RE: Hennepin East Pond 2 and Addendum Closure/Post-Closure Plan

RE: Response to IEPA's May 2, 2019 Comment Letter on both the Closure / Post-Closure Plan for the Hennepin East Ash Pond No 2 and the Closure Plan Addendum Hennepin East Ash Pond 2

**RE:** Response to IEPA Comments – Closure and Post-Closure Care Plan for the Hennepin East Ash Pond No. 2, and Closure Plan Addendum Hennepin East Ash Pond No. 2 which includes closure of Ash Pond No. 4

RESPONSE TO IEPA COMMENTS  
 EAST ASH POND NO. 2  
 DYNEGY MIDWEST GENERATION, LLC  
 HENNEPIN POWER STATION, HENNEPIN, ILLINOIS

**Figure A. Observed vs Modeled Median Groundwater Elevations for Representative Wells**

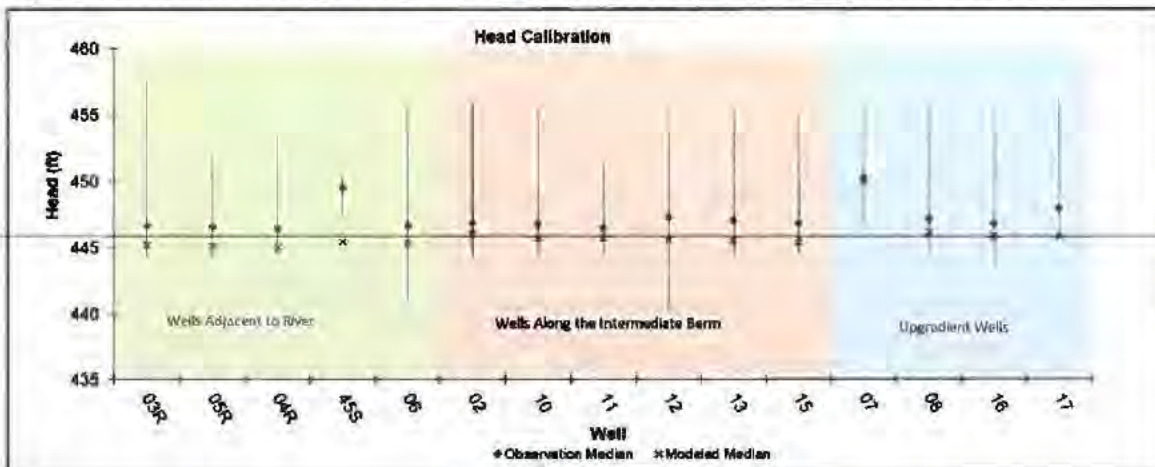
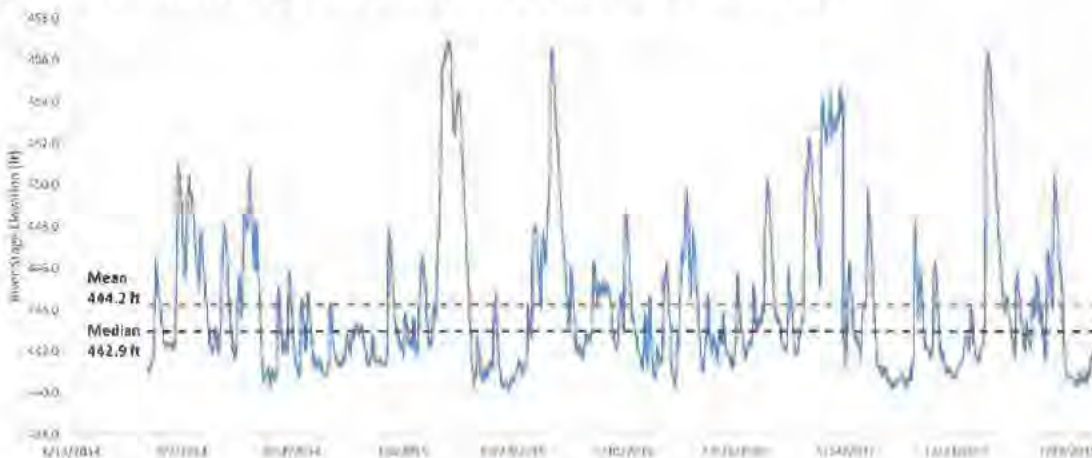
*The observed and modeled head elevations displayed in Figure 3-1, do not match well at many of the data points. Further, Section 3.2 does not include a description of the relative standard deviation given as a percentage of standard deviation to the data mean. Typically, this value should be less than 10%. Please refer to the Wood River Closure Plan, Part 2 Appendix D, Section 3.4 Calibration Flow and Transport Model Results, and Figure 3-6 as an example. An inadequately calibrated model may significantly impact predicted compliance with groundwater standards. Please provide documentation that the model submitted did meet the 10% calibration criteria, or rework the model to meet the 10% criteria, and rerun the predictive flow and transport modeling.*

**Median modeled heads match median observed heads:** Figure A below plots the range (maximum and minimum) of head observed for a distribution of wells that is representative of the monitoring network with the median observation value and the modeled value illustrated for comparison. Median modeled heads were calculated from the model results generated after dewatering of Pond 2 (1997 through 2019). This period is representative of long-term groundwater flow conditions during the bulk of the observed data collected. The predicted heads fell in the range of monitoring data at these wells with the exception of well 45S which is lower than the range. The median head at 45S is 449.5 and is the second highest value at the site; only well 07 at the upgradient edge of the monitoring network has a higher median head value. During individual sampling events the heads at 45S are consistent with neighboring wells, indicating the higher median observed value is due to the limited amount of monitoring data available for this newer well which hasn't captured a representative range of periodic high and low head fluctuations observed at other wells. Well 06 (located near well 45S) has more observations and is more consistent with other wells (Figure A below). The predicted heads were all lower than their corresponding observed medians at each well, indicating the model generally under-predicts median head values. The average difference between the observed median and the modeled head for these wells is approximately 1.4 feet. The average range in head (maximum – minimum observed) is approximately 10.6 feet at each well. The average difference in head (1.4 feet) over the average range in head (10.6 feet) is 13.2%. When the observations from 45S are removed, the average difference in head reduces to 1.2 feet while the average range in head increases to 11.2 feet; resulting in a value of 10.7%. The difference in head compared to the range of values at these wells approaches the recommended value of 10% or less; and, demonstrates how the modeled heads are representative of long-term (median) flow conditions discharging to the Illinois River.

Due to the lack of representative data collected from well 45S, this well was removed from further calibration evaluations involving the median of observed values. Well 06 is more representative of heads in this portion of the site.

**Figure D. Boron vs Lithium**

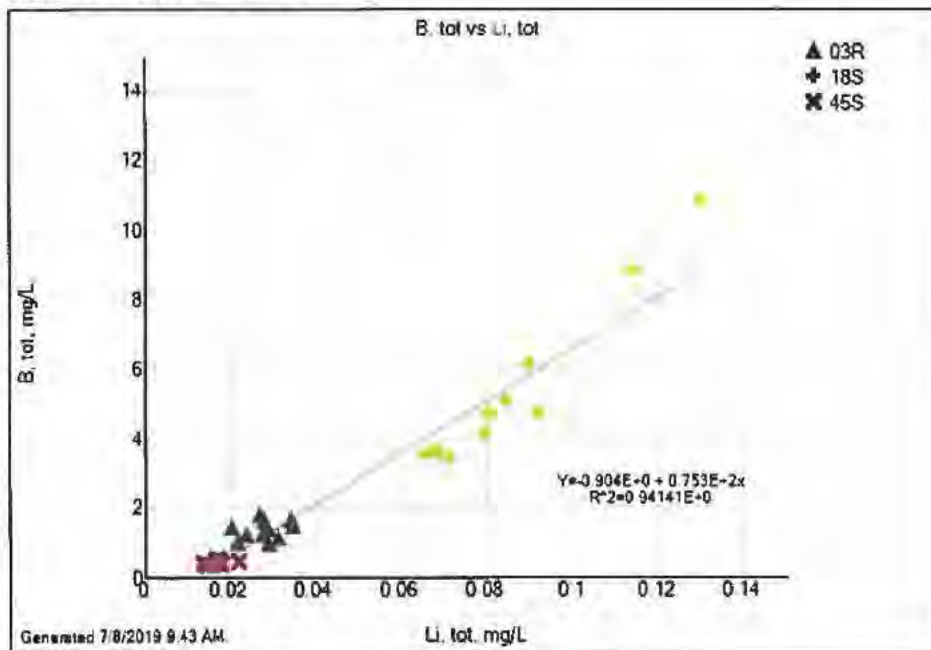
Available monitoring results from monitoring conducted by Vistra during 2018 indicates that both Lithium and Molybdenum at statistically significant concentrations in some down gradient monitoring wells. Please provide an evaluation of the estimated time required to meet applicable groundwater protection concentrations for these constituents, including an enhanced cover scenario, in addition to the Part 257 compliant cover and the baseline case.

Comparisons of the molybdenum and lithium concentrations to boron (Figures D through F below) indicate that these compounds are relatively well correlated at downgradient wells of interest 18S, 3R, and 45S. Boron and lithium have a strong linear correlation coefficient ( $R^2$ ) of 0.94 (Figure D). Boron and molybdenum have a good linear correlation coefficient of 0.72 (Figure E); and, molybdenum shows a stronger exponential correlation coefficient of 0.94 with boron (Figure F), likely due to sorption of molybdenum on aquifer materials as discussed above. Based on the data collected and the existing strong linear or exponential correlations, concentrations of lithium and molybdenum are expected to decrease at similar rates to those of boron as predicted in the computer model.
